APPLICATION FOR VARIANCE

Tufts University
114 Professors Row, Somerville, MA 02155

Tufts University – 114 Professor’s Row Variance Requests

Date: June 10, 2022 Project#: 199103
To: Architectural Access Board
From: Jeff Perras, P.E. – Code Red Consultants
Re: Tufts University – 114 Professor’s Row – Variance Requests
Cc:

FIGURE 3 – FRONT RAMP

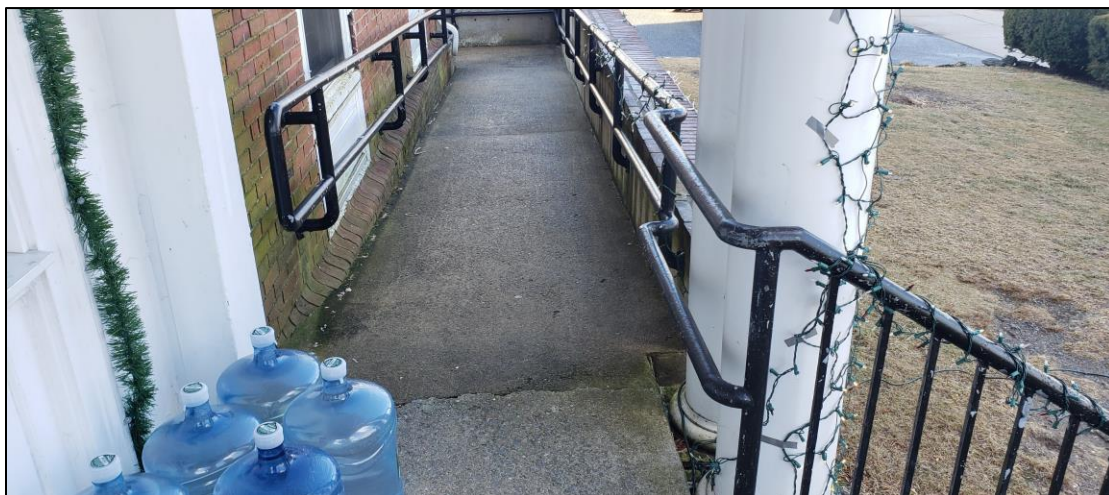
24.5.3, 24.5.4, 24.5.8 & 24.3 – Ramp Handrails

The ramp leading to the front entrance of the building is equipped with handrails that do not comply with 521 CMR. These deficiencies include the following:

- Handrails are interrupted by newel posts (521 CMR 24.5.3).
- Handrails are not provided with 12 inch extensions at the top and bottom (521 CMR 24.5.4).
- Handrails come within close proximity to the adjacent walls and reduce the clear space below 1.5 inches (521 CMR 24.5.8).
- Handrails are jog around building columns at the top of the ramp, reducing the clear width below 48 inches (521 CMR 24.3).

The deficiencies with the handrails are dimensional and correcting them will be excessive cost without substantial benefit to building occupants. The following is the cost estimate to replace the handrails is included in the overall cost to make the entire ramp accessible as noted below and in Appendix B (\$168,750).

FIGURE 6 - REAR BASEMENT ENTRY

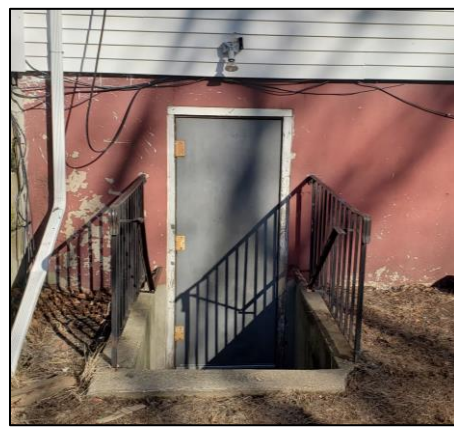
25.1 - Entrances

All public entrance(s) of a building or tenancy in a building shall be accessible. As previously mentioned, the front and rear entrances are being upgraded as part of this renovation to be fully accessible; however, there is a 2nd rear entrance into the Basement and two rear entrances to the First Floor that are not accessible. Due to site constraints, the size of the building, and the topography of the site, it is our opinion that making these entrances accessible would result in excessive cost without substantial benefit to building occupants.

Feature	Cost Estimate
Rear Basement Entry	\$196,649
Rear Patio Entry with Ramp (or Lift)	\$333,950 (\$261,800)
Kitchen Entry with Ramp (or Lift)	\$138,000 (\$141,750)
Front Door Ramp Entry	\$168,750
Total	\$837,349 (\$768,949)
